Subject: Operations Maintenance Facility: East – Bulletin No. 0032

Bulletin No.	Description	Importance	Cost
0032	PCC Pavement at MOW	Normal	Unanticipated

PROJECT: LINK OPERATIONS & MAINTENANCE FACILITY: EAST**STANTEC PROJECT NO:** 204820133**DATE:** 12/12/2019**CONTRACT NO.:** RTA/CN 002-16**ORIGINATOR:** JIM MCPHERSON**DISCIPLINE:** CIVIL

Subject: Design bulletin DB032 for DP2 changes

DRAWING No.:	Y02-CPD001
LOCATION ID:	Y02
SHEET No.:	REV: A

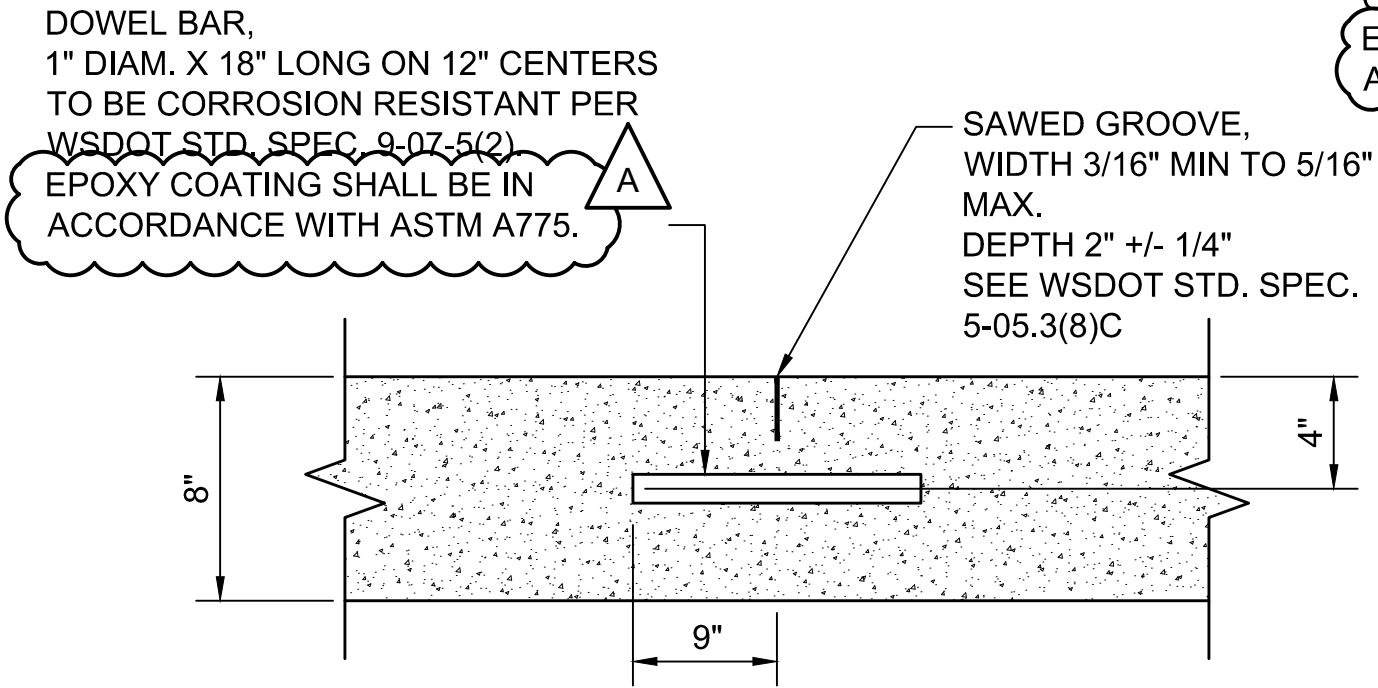
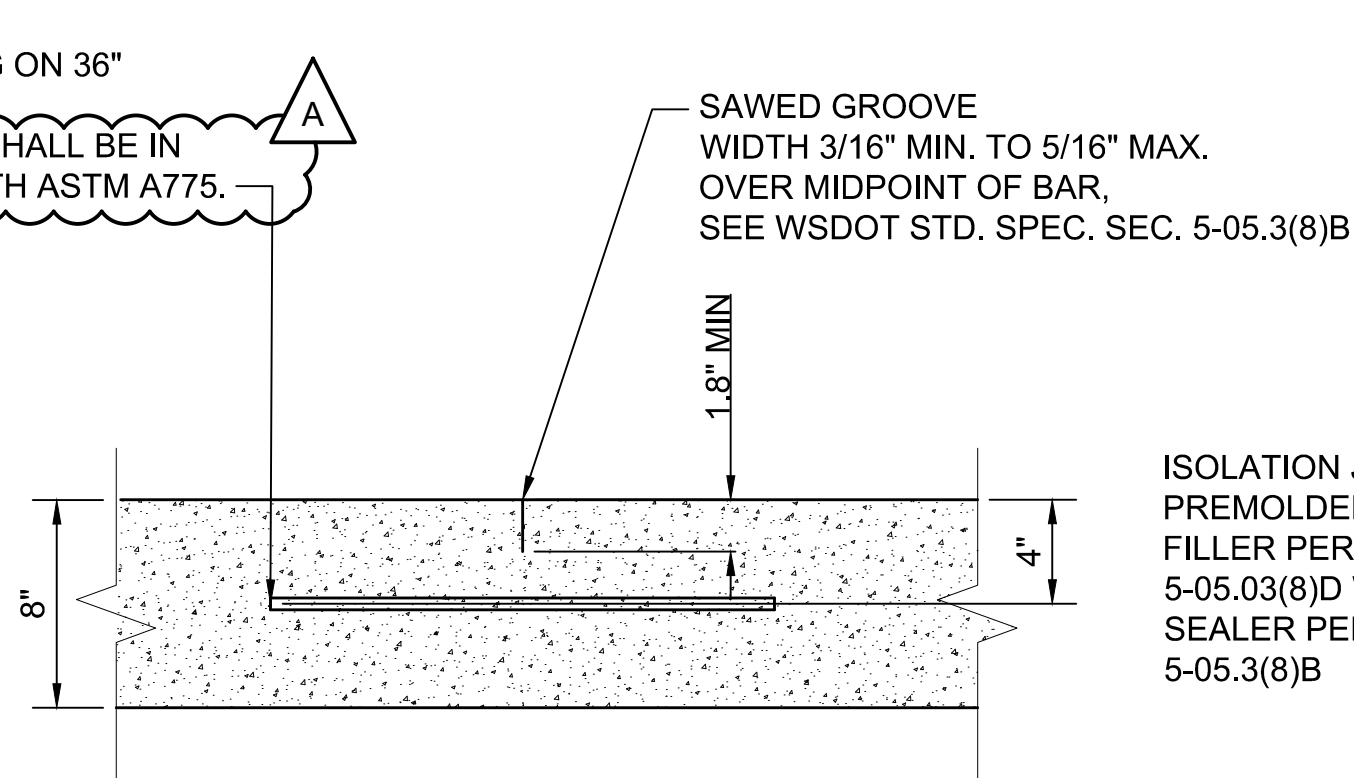
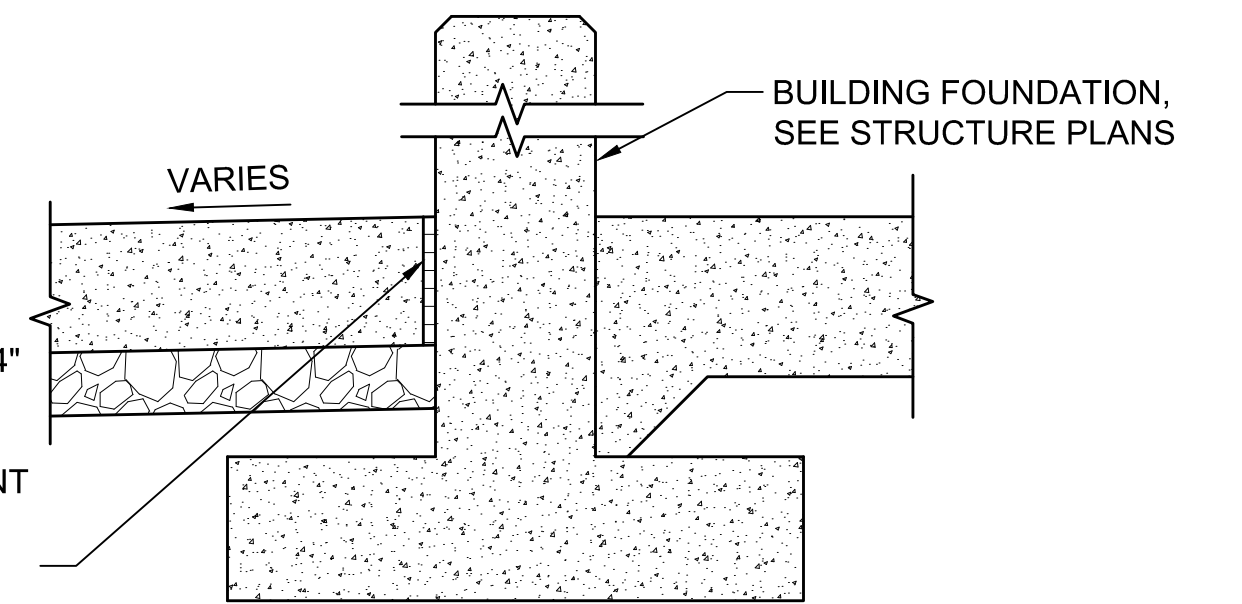
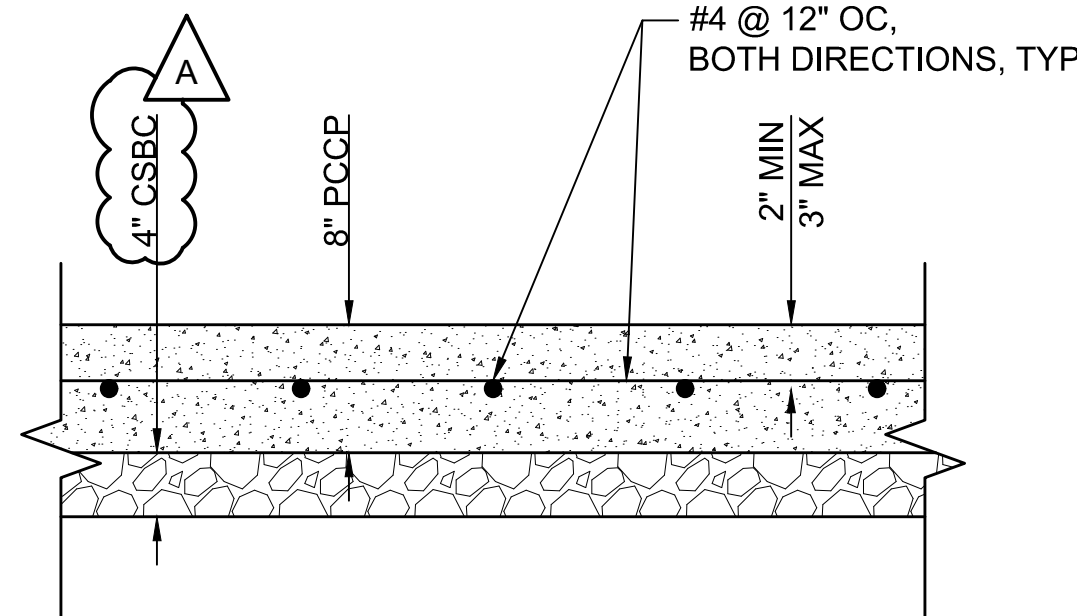
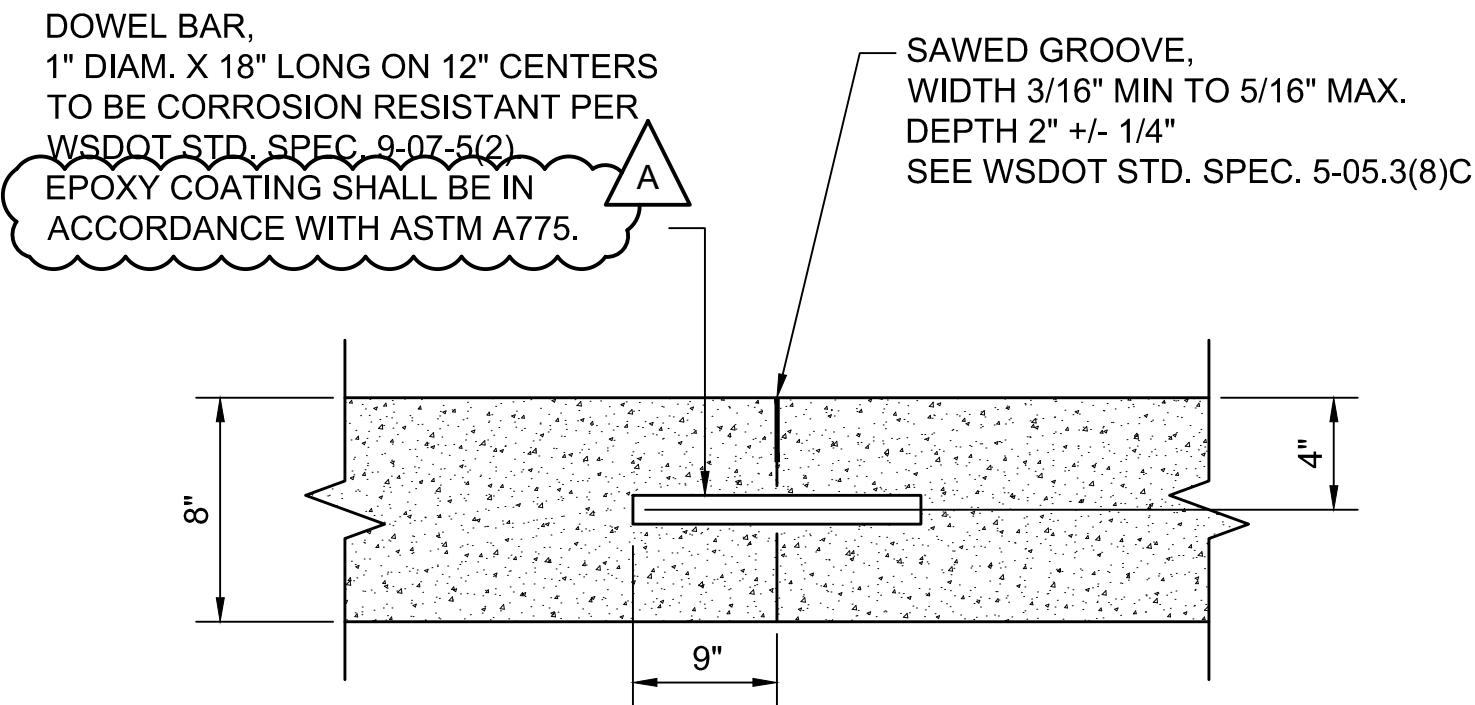
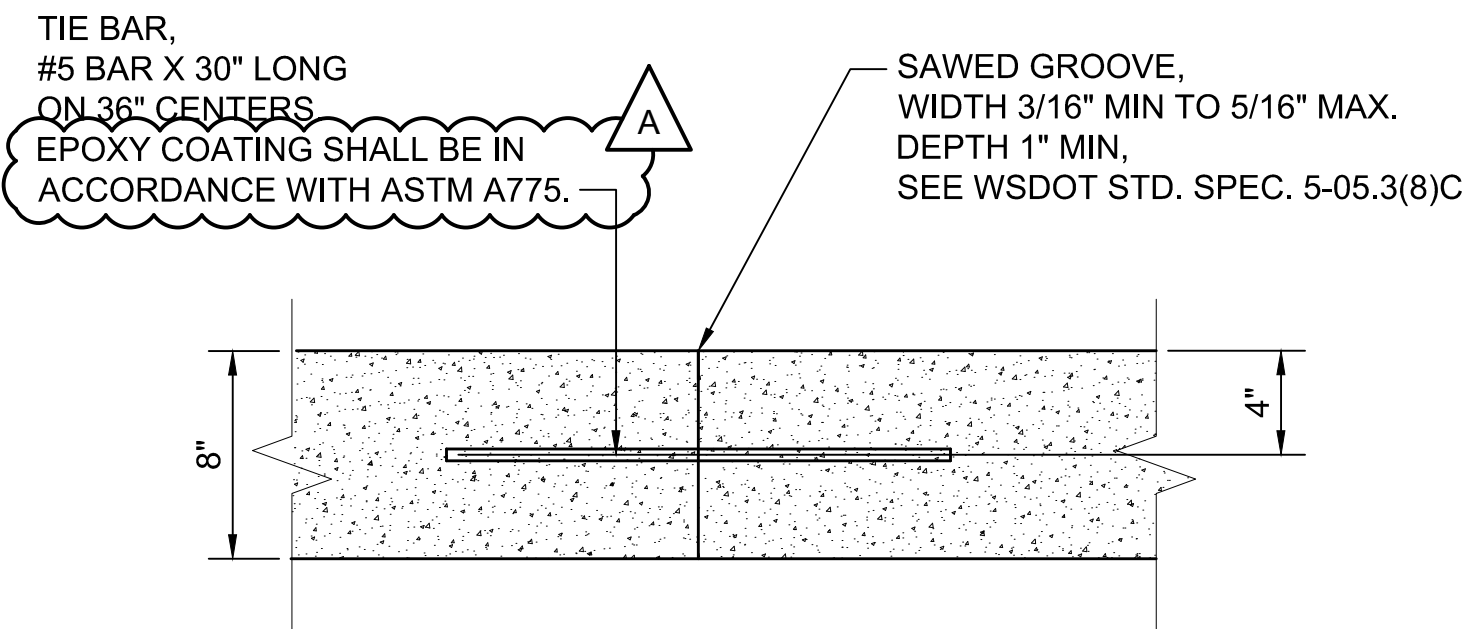
Y02-CPD001 – New sheet, PCCP joint details (ADDED EXOPXY COATING SPEC CALL-OUT)

DRAWING No.:	Y02-CPP201
LOCATION ID:	Y02
SHEET No.:	REV: A

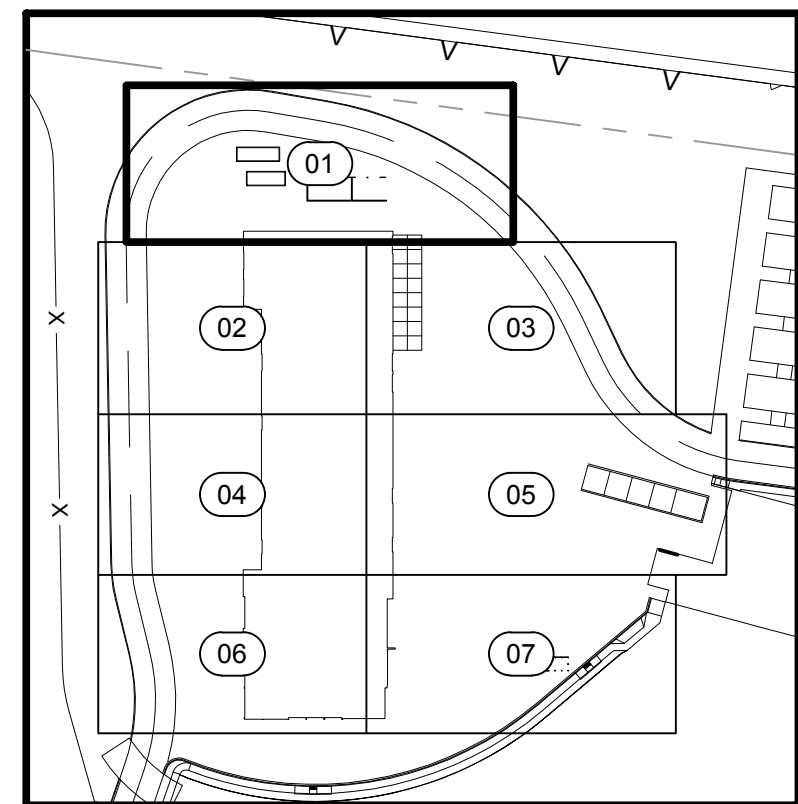
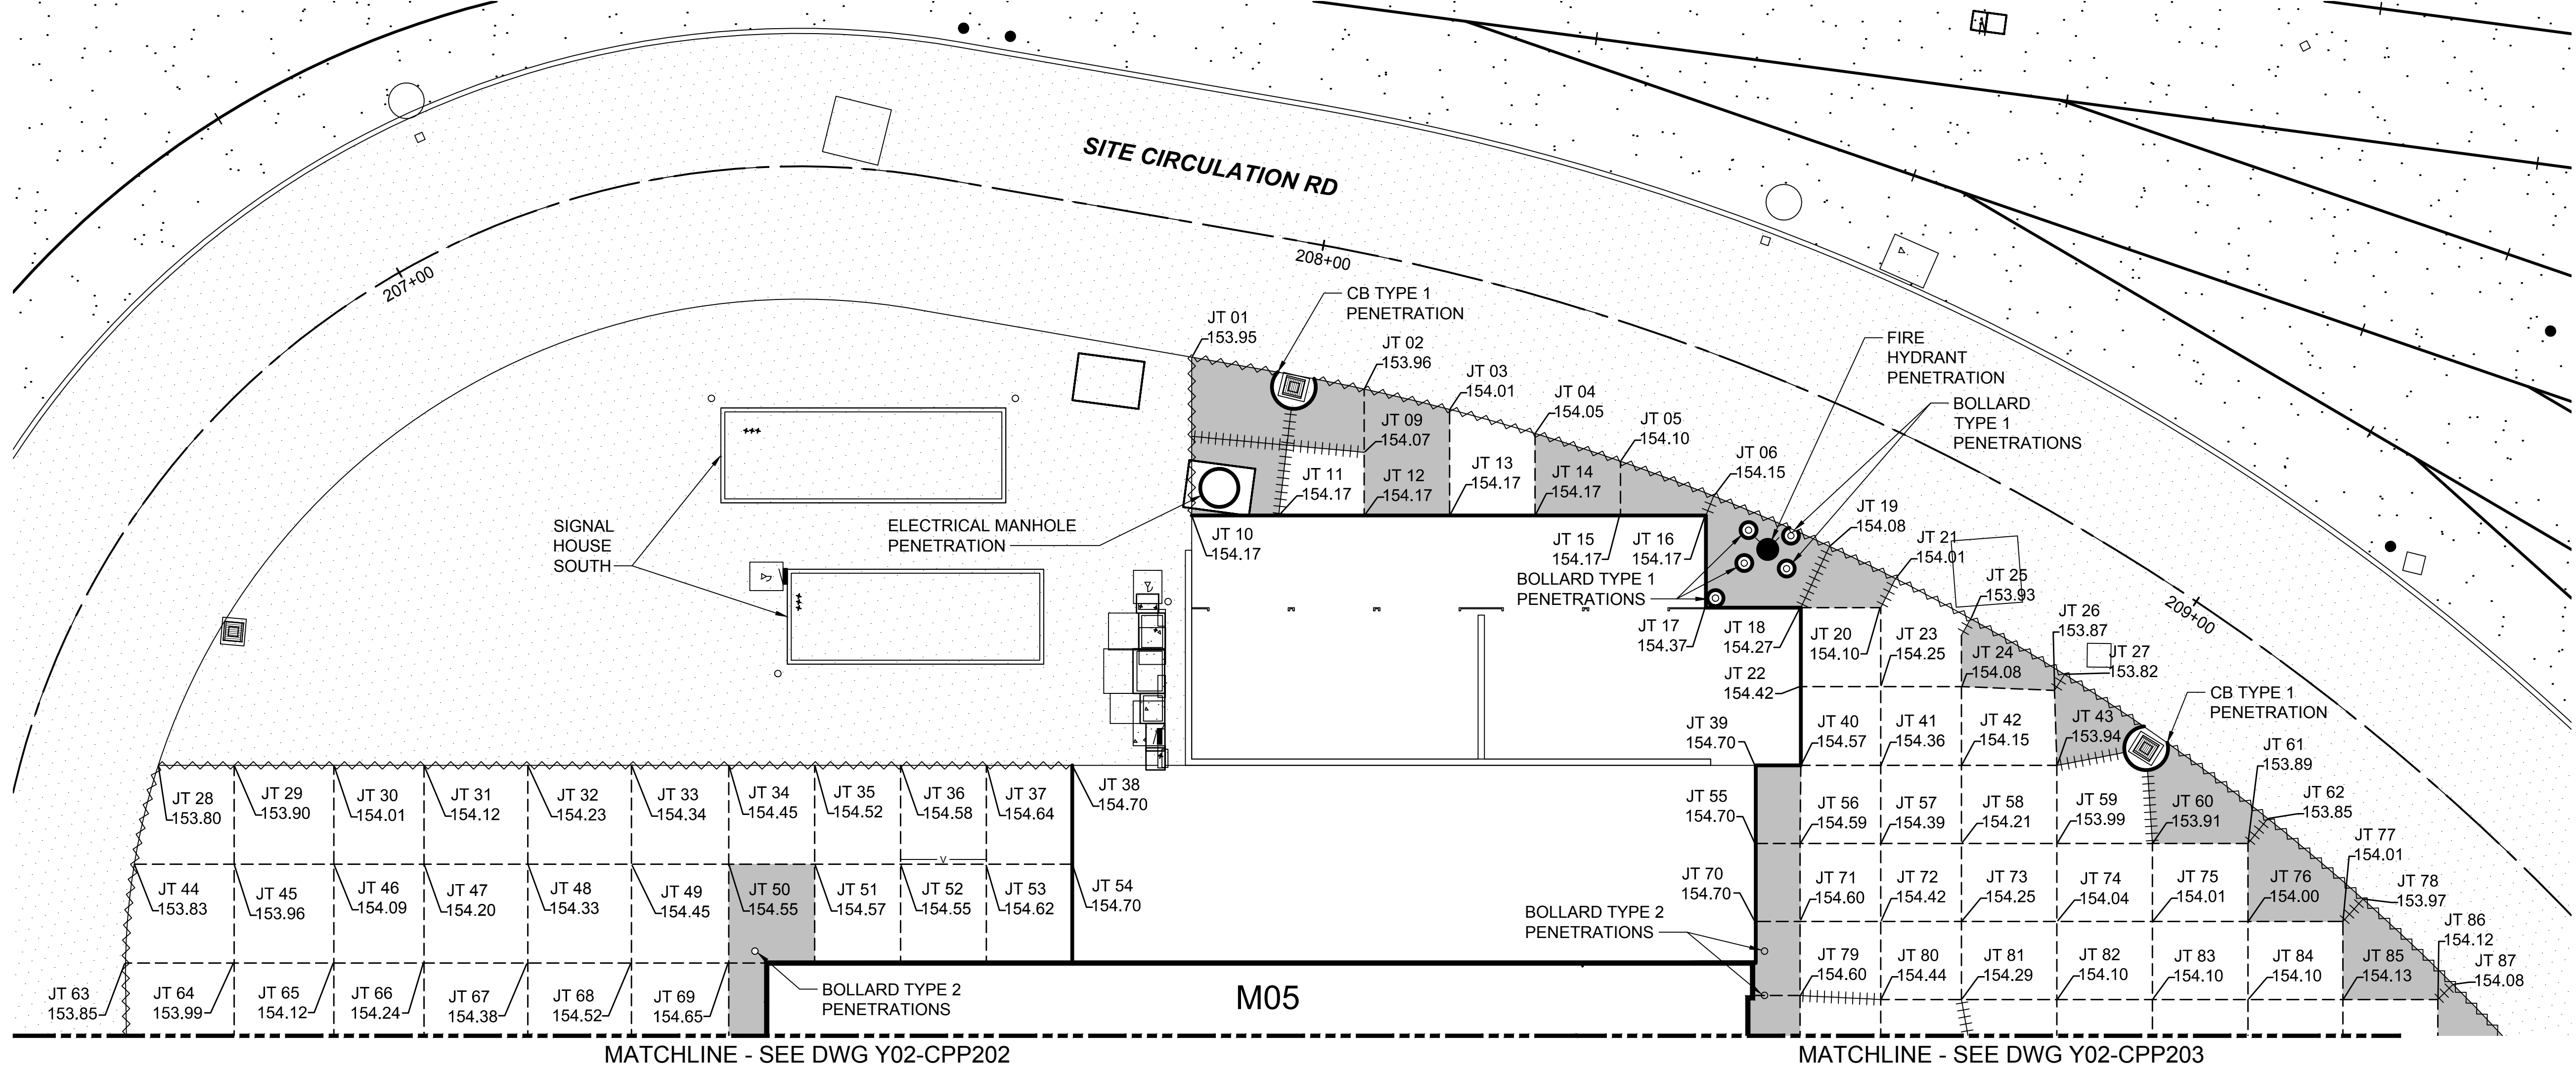
Y02-CPP201 – New sheet, jointing plan (UPDATED ELEVATIONS)
Y02-CPP202 – New sheet, jointing plan (UPDATED ELEVATIONS)
Y02-CPP203 – New sheet, jointing plan (UPDATED ELEVATIONS)
Y02-CPP204 – New sheet, jointing plan (UPDATED ELEVATIONS)
Y02-CPP205 – New sheet, jointing plan (UPDATED ELEVATIONS)
Y02-CPP206 – New sheet, jointing plan (UPDATED ELEVATIONS)
Y02-CPP207 – New sheet, jointing plan (UPDATED ELEVATIONS)
Y02-CPP208 – New sheet, PCCP joint elevation table (UPDATED ELEVATIONS)
Y02-CPP209 – New sheet, PCCP joint elevation table (UPDATED ELEVATIONS)
Y02-CPP210 – New sheet, PCCP joint elevation table (UPDATED ELEVATIONS)
Y02-CPP211 – New sheet, PCCP joint elevation table (UPDATED ELEVATIONS)
Y02-CPP212 – New sheet, PCCP joint elevation table (UPDATED ELEVATIONS)

VARIOUS ELEVATION CHANGES,
SEE CLOUDS ON POINT TABLES.
